TO: Mayor Andre Dickens, City of Atlanta
ATTN TO: Monique Forte, Planner III, City of Atlanta
FROM: Mike Alexander, Director, ARC Center for Livable Communities
RE: Development of Regional Impact (DRI) Review

Name of Proposal: Moreland and Custer DRI 3586

Description: A DRI review of a proposal to construct 260 townhomes, 413 multi-family residential units, and 19,500 SF of retail space on a roughly 32 acre site at the SE corner of Moreland Avenue and Custer Avenue in southeast Atlanta. The project site, currently developed as a large strip mall with an extensive surface parking area, was a key focus of the 2008 South Moreland Avenue Livable Centers Initiative Study.

GSWCC CERT. (LEVEL II)	0000062135
DRAWN BY	HED
DESIGNED BY	MCP
REVIEWED BY	BWS
DATE	04/21/2022
PROJECT NO.	015002008
TITLE	
DRI SITE PLAN	
SHEET NUMBER	
C0-20

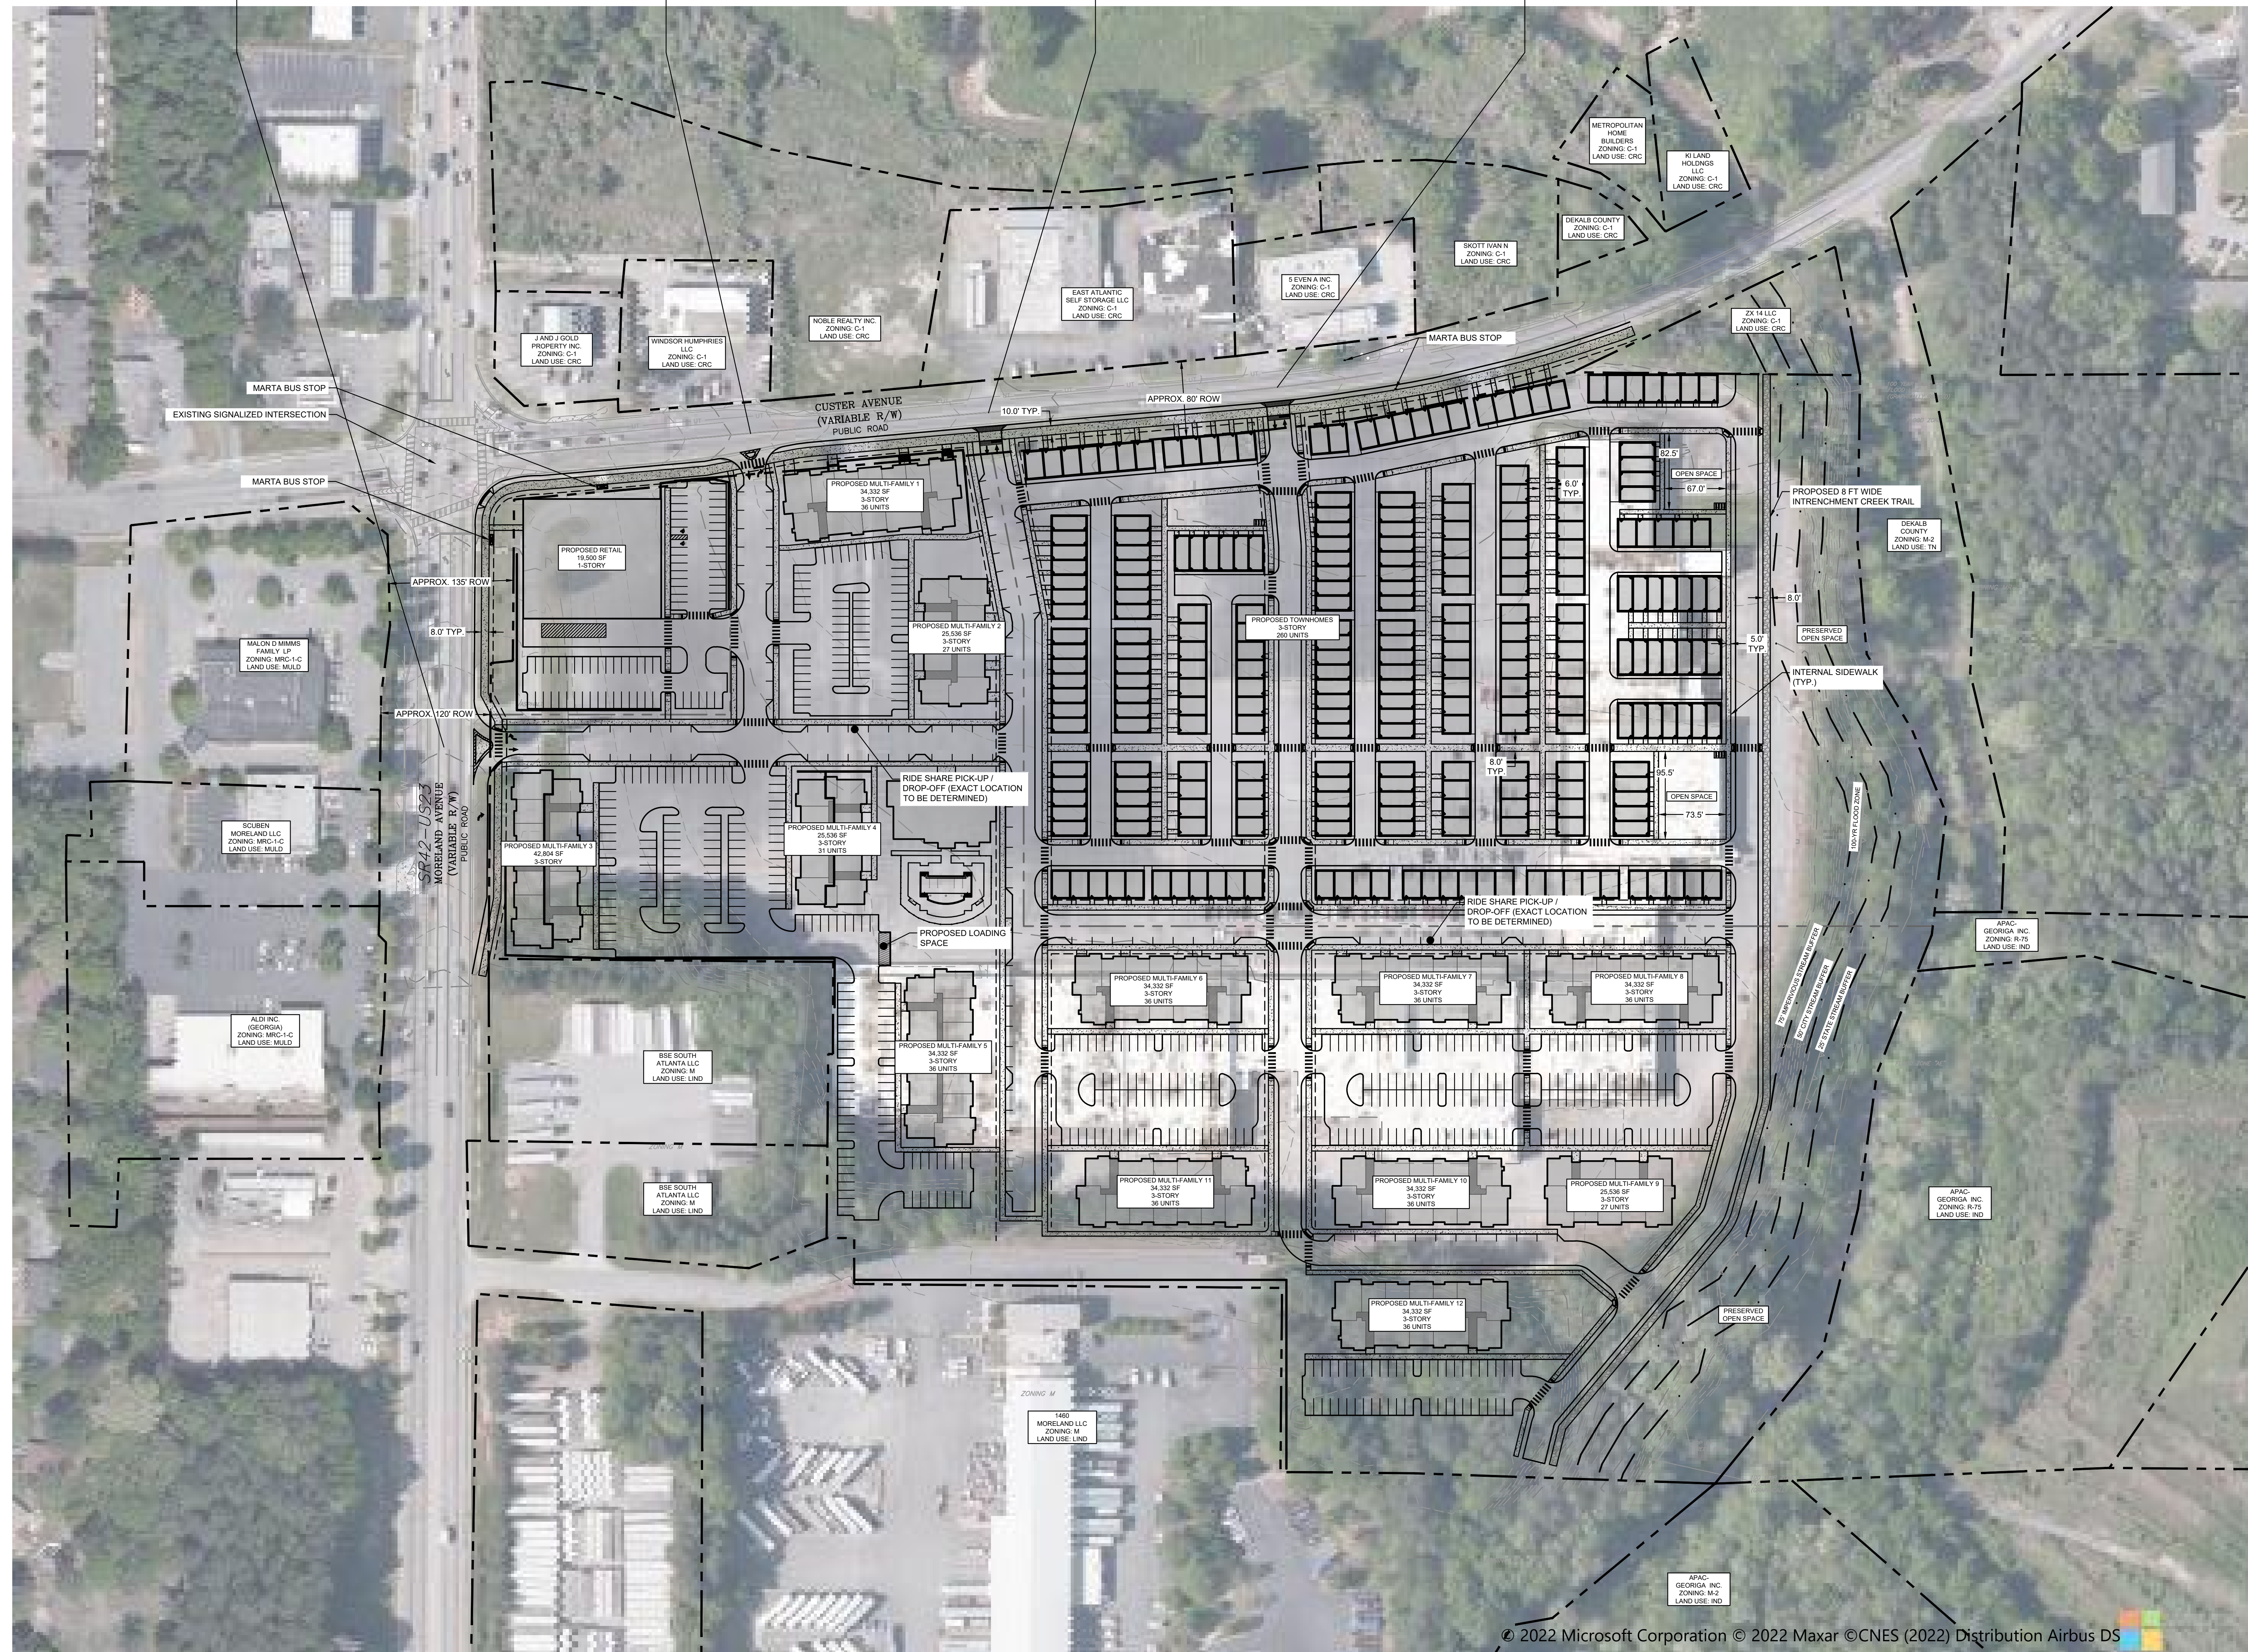
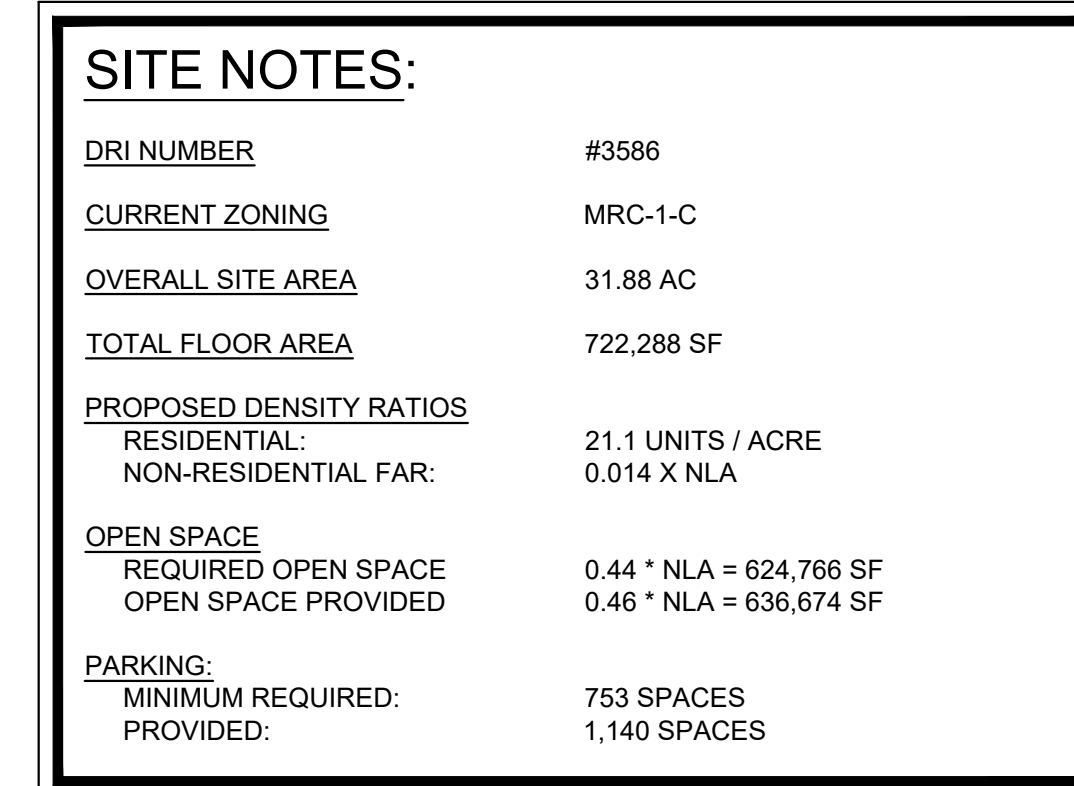
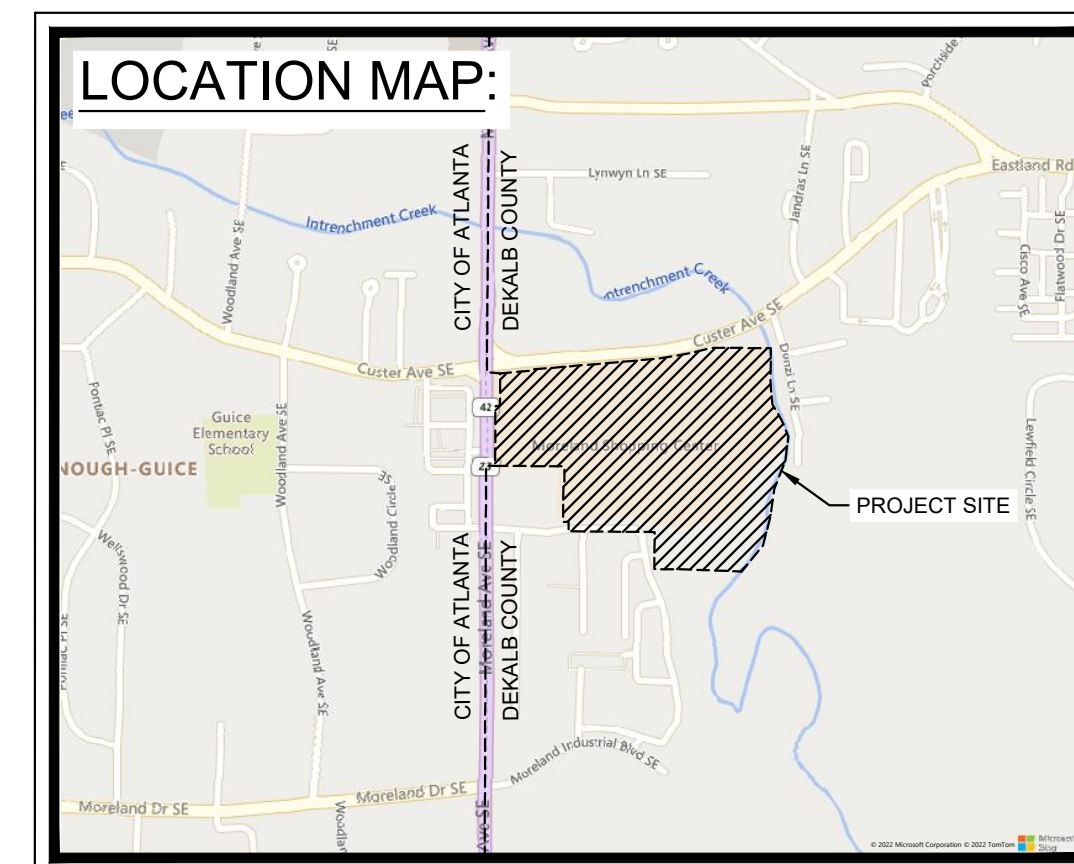
The street grid misses the key opportunity to create principal north-south and east-west axes for both connectivity and placemaking purposes. A central east-west axis from the entrance on Moreland and terminating with an overlook at the Creek and possibly flanked by small pocket parks would help establish a much stronger sense of place and provide better connectivity.

The two proposed small green spaces on the eastern edge are positive design elements but there is unmet need for green space closer or adjacent to the multi-family buildings and as a potential placemaking element off of Custer or Moreland.

The proposed one-story retail building at the corner of Moreland and Custer will service users outside of the site but is unlikely to be a walking destination for project residents. The LCI contemplated a much taller mixed use building to establish an urban presence at this key corner; a one-story building will not accomplish this or be differentiated from the prevailing existing one-story retail strip condition along Moreland.

The proposed plan appears to show stub-outs at the southern ends of the north-south roads on the east and west sides of the site which will provide future connectivity to the parcels to the south when they are eventually redeveloped. A deceleration lane proposed for driveway A on Moreland Avenue would diminish the pedestrian experience and safety and is not in keeping with the walkability vision for the site.

The three site driveways proposed for the Custer Avenue frontage conflict with the goal of providing a safe enhanced pedestrian route in the form of the South River Trail segment included in the design; a reduction to two driveways would significantly limit this conflict.

A total of 1,197 surface parking spaces are proposed. No EV charging or bicycle parking spaces appear to be proposed; inclusion of optimal numbers of both would be supportive of regional EV infrastructure development and multi-modal transportation goals.

ARC Natural Resource Group full comments are attached. Both the USGS coverage for the project area and the submitted site plan show Intrinchment Creek running north to south through the easternmost end of the property. The site plan shows a 50-foot undisturbed buffer and a 75-foot impervious buffer which conform to the City of Atlanta Stream Buffer Ordinance, as well as the State 25-foot State Erosion and Sedimentation Control Buffer on the west side of the stream. While the project property line is within the buffers for most of the eastern side of Intrinchment Creek, the buffers should be noted on that side of the stream, even if applying their full widths is not possible on the property.

Also, an 8-foot-wide trail, identified as the proposed Intrinchment Creek Trail, is shown between the proposed development and the buffers. In two places, it appears to be at the edge of the 75-foot City buffer. Any intrusion into that buffer may require a variance from the City. Any unmapped streams on the property may be subject to buffers required under the City of Atlanta Stream Buffer Ordinance. Any waters of the state on the property will be subject to the State 25-foot Erosion and Sedimentation Control Buffer.
